## **ADDENDUM NO. 2**

### **BROAD RIVER WWTP IMPROVEMENTS**

### **GAFFNEY BOARD OF PUBLIC WORKS**

**Date: May 15, 2025**

# C6

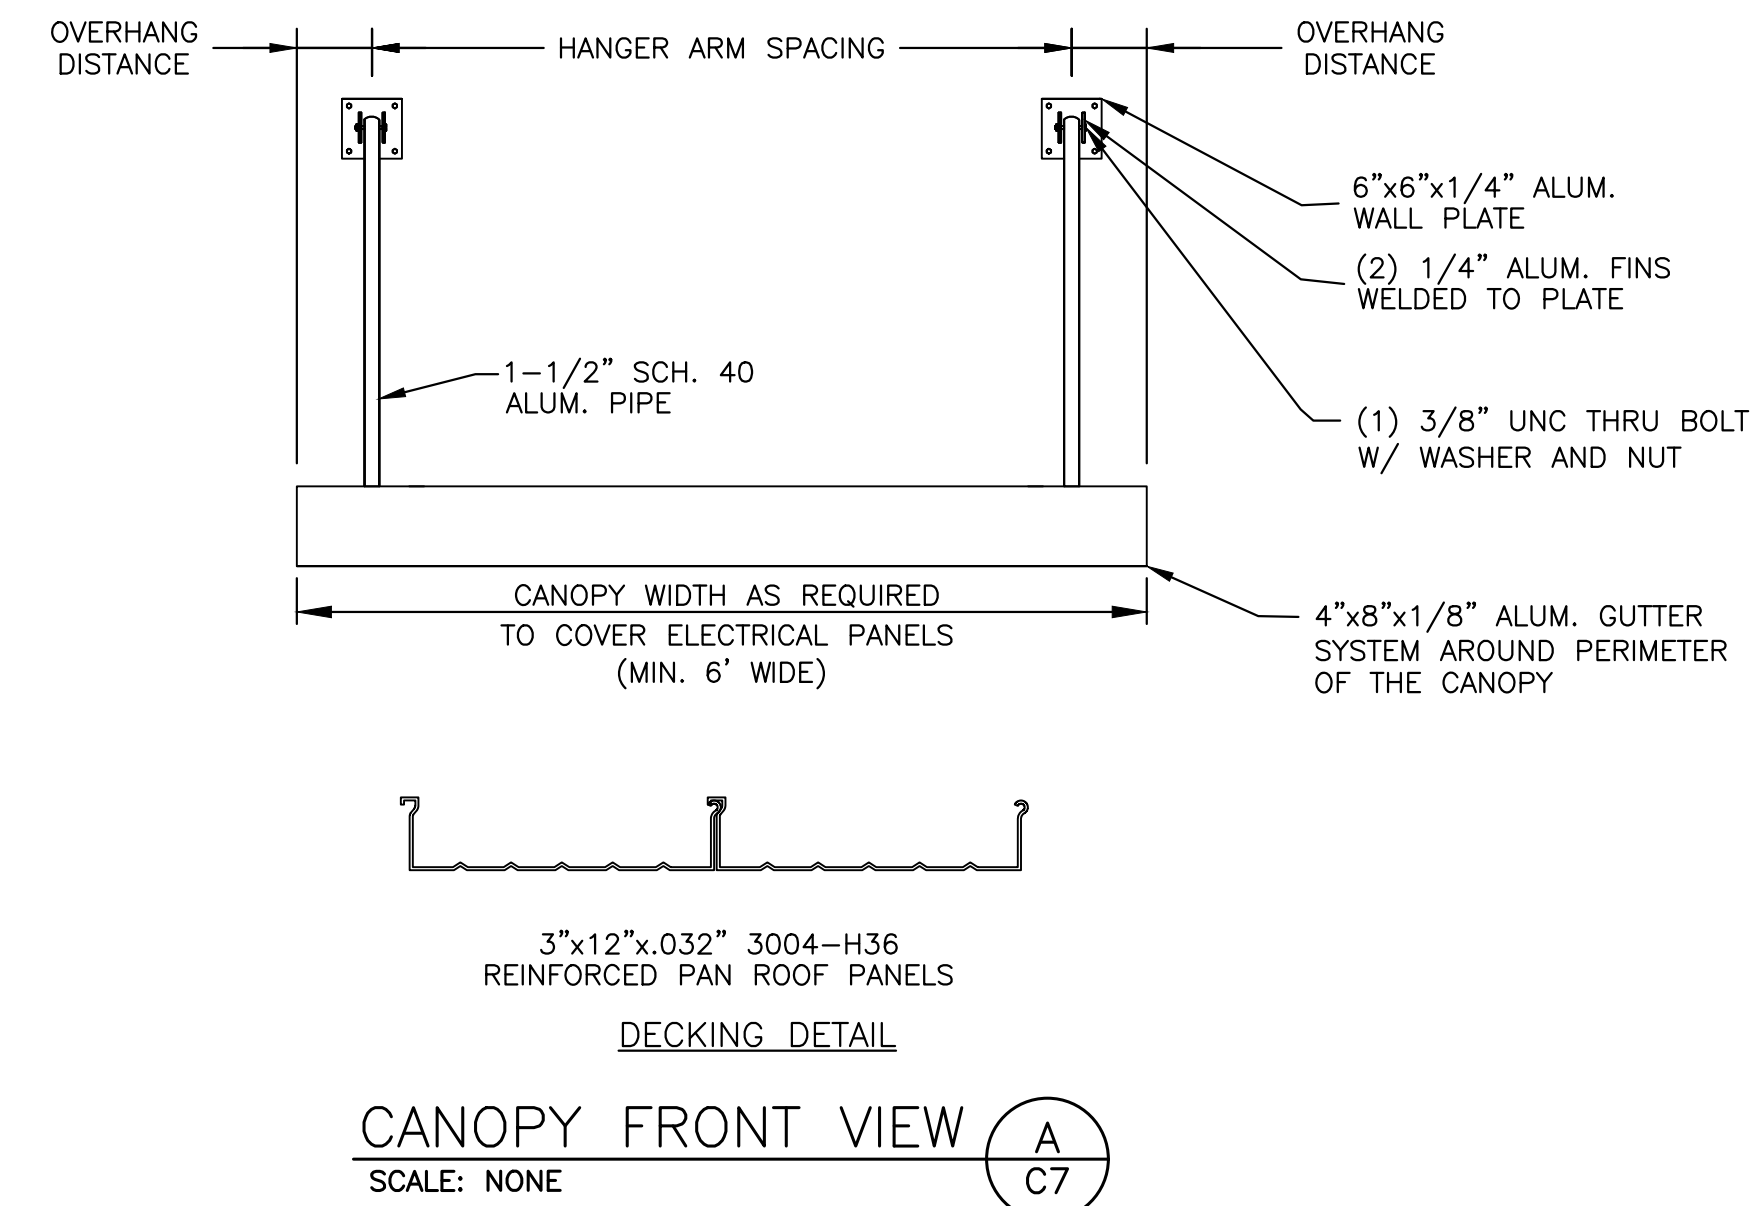
4. At the Providence Creek pump station, sheet C7 calls for a new pressure gauge assembly, but the previous three sheets call out the pressure gauge assemblies as being existing. Are we providing a new pressure gauge assembly/assemblies?

##### **3. Sheet C6 (Providence Creek Pump Station Plan & Section)**

- A. Added note to install one new pressure gauge assembly. See the revised Sheet C6 which is attached to this addendum.

**Answer: Sheets C6 and C7 of the plans have been revised to show where the one new pressure gauge assembly will be located. The rest of the existing pressure gauge assemblies will remain as is.**

C9

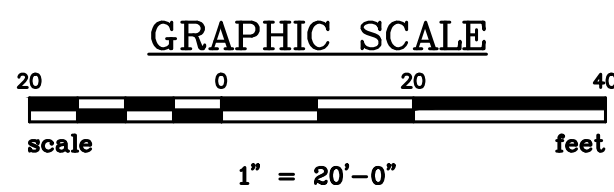
##### **5. Sheet C9 (Broad River WWTP Overall Site Plan)**

- A. Added note showing new stockpile area for material removed from the new tank excavation. See the revised Sheet C9 which is attached to this addendum.

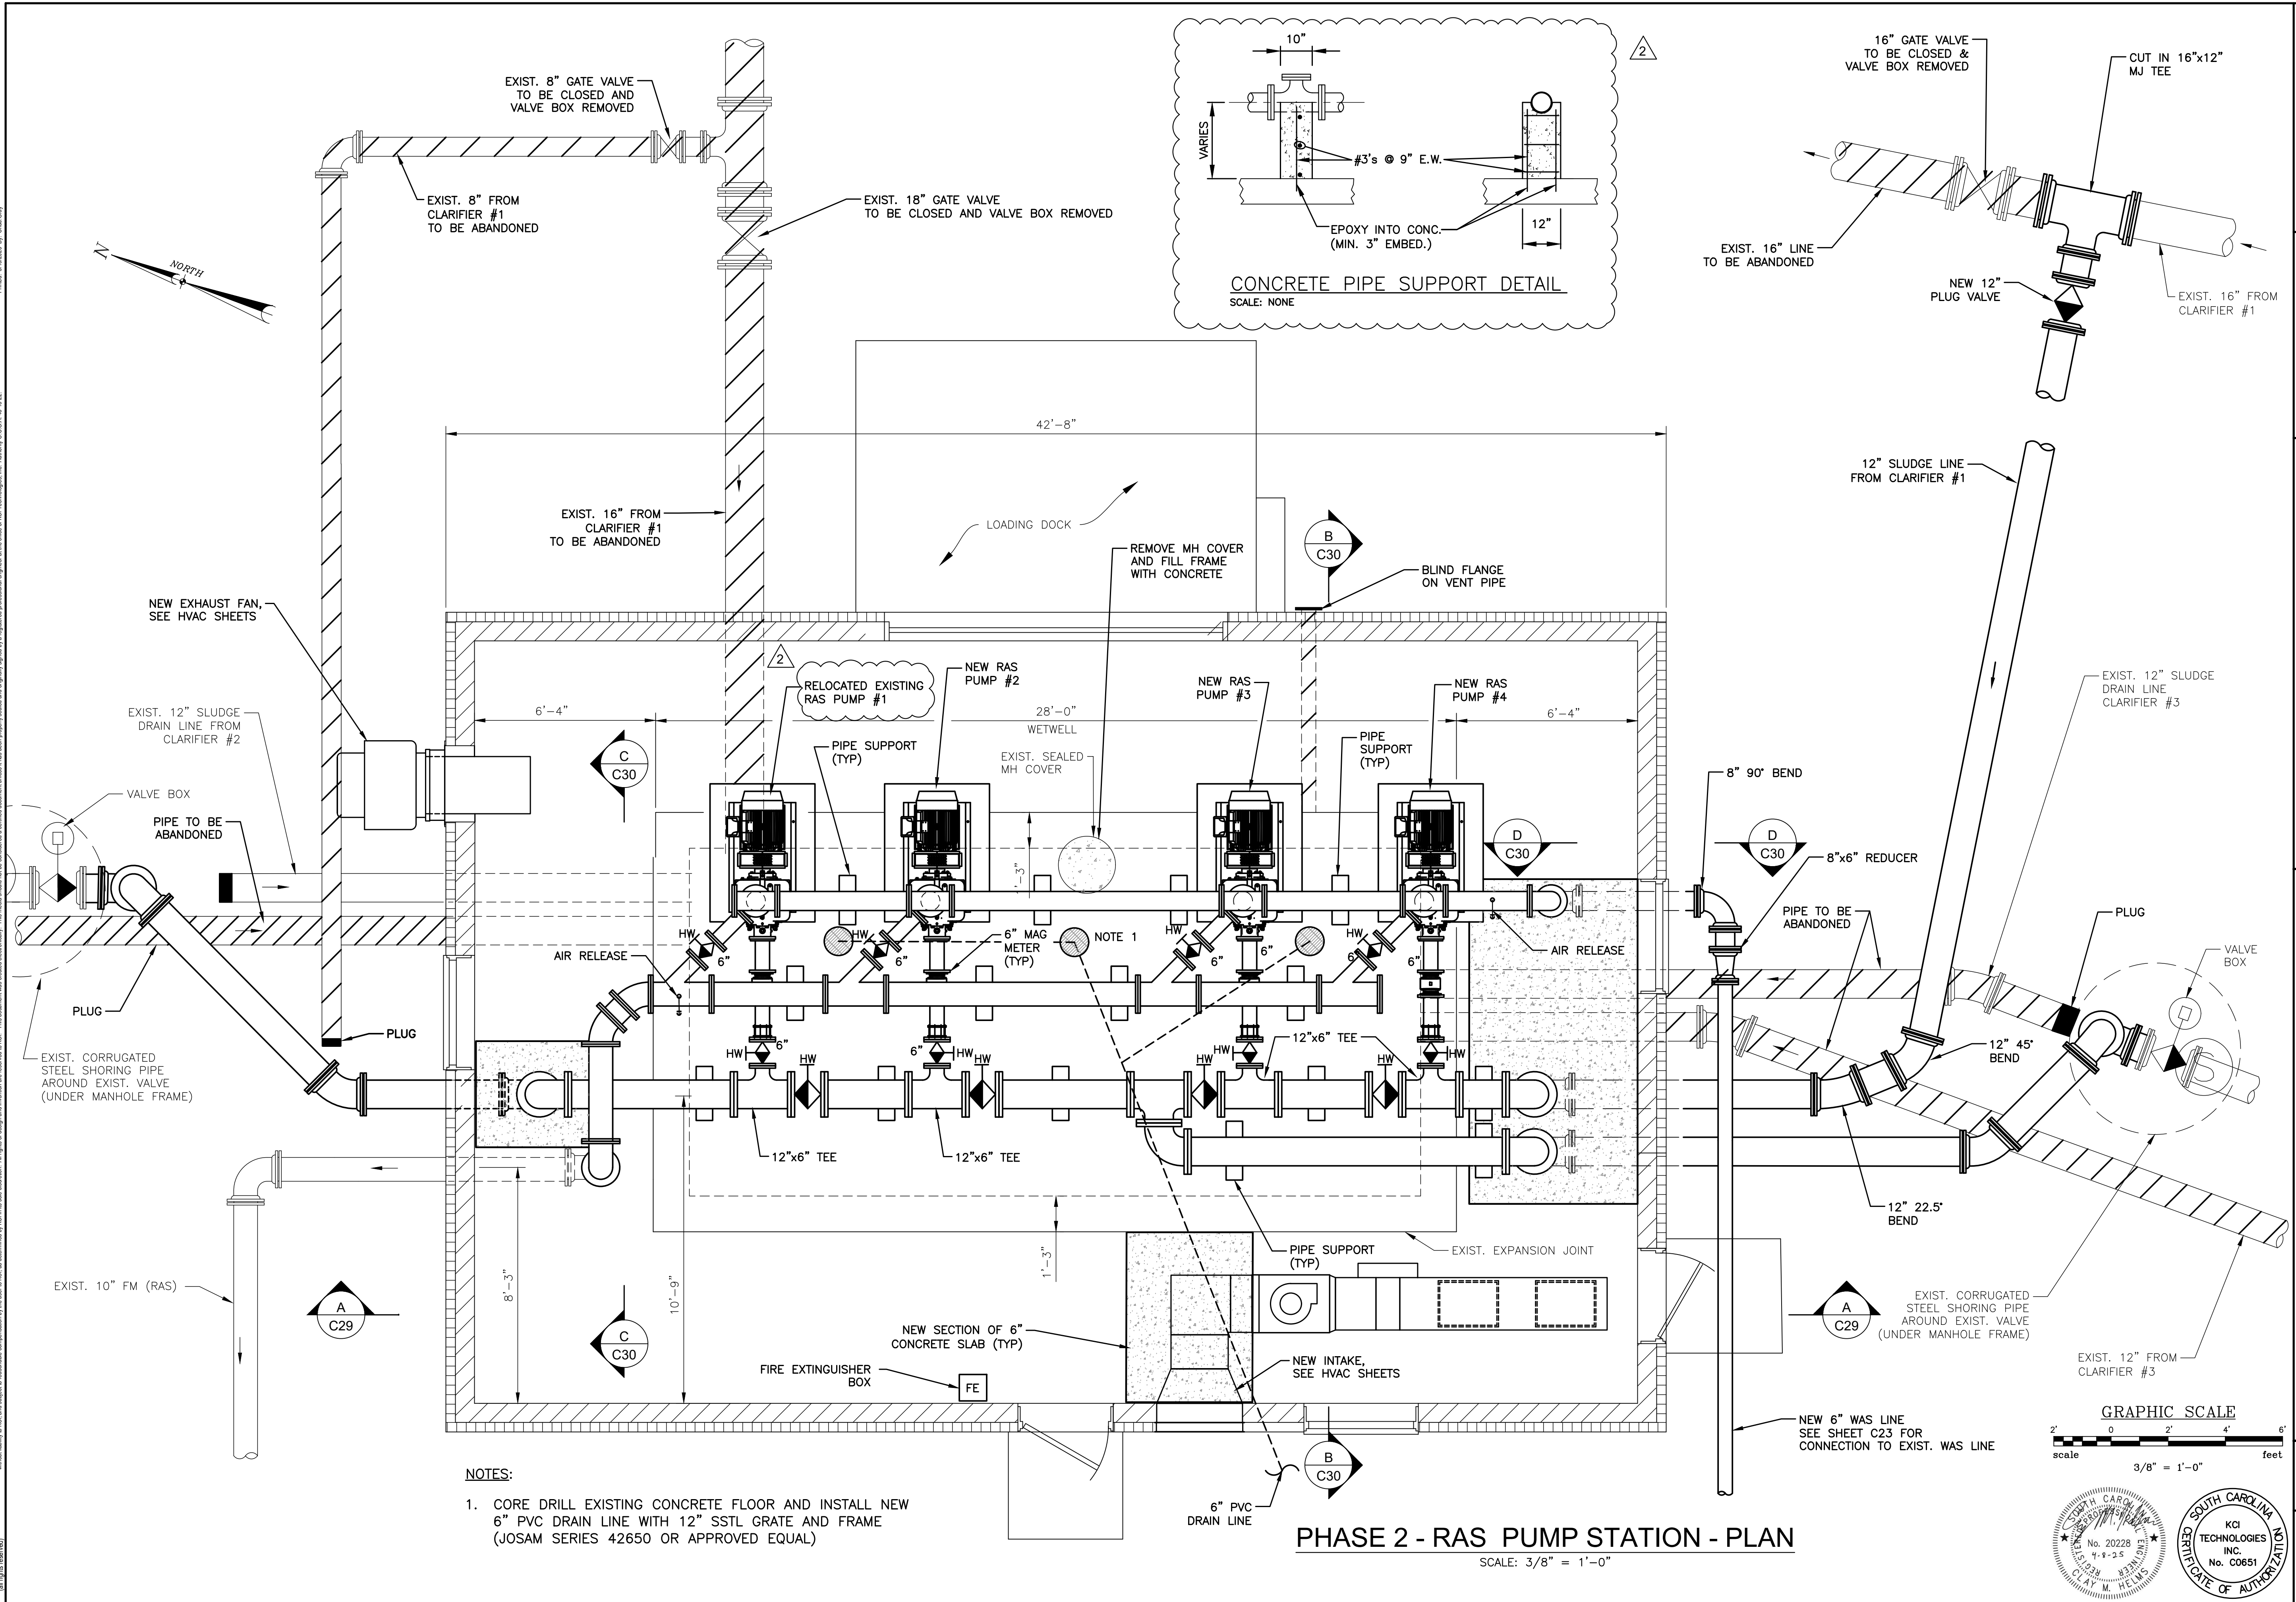
**8. Sheet C28 (Exist. RAS Pump Station Phase 2 Renovation Plan)**

- A. Change the call out note for RAS Pump #1 to designate it as the existing pump that will be relocated. See the revised Sheet C28 which is attached to this addendum.
- B. Add the "Concrete Pipe Support Detail" to this plan sheet. See the revised Sheet C28 which is attached to this addendum.

**Answer: Sheet C28 of the plans has been revised designating which pump will be the existing relocated pump, and where it is being relocated.**

**Answer: The intent is to have concrete pier pipe supports (similar to the detail shown on sheet C8 of the plans). A pipe support detail has been added to Sheet C28.**
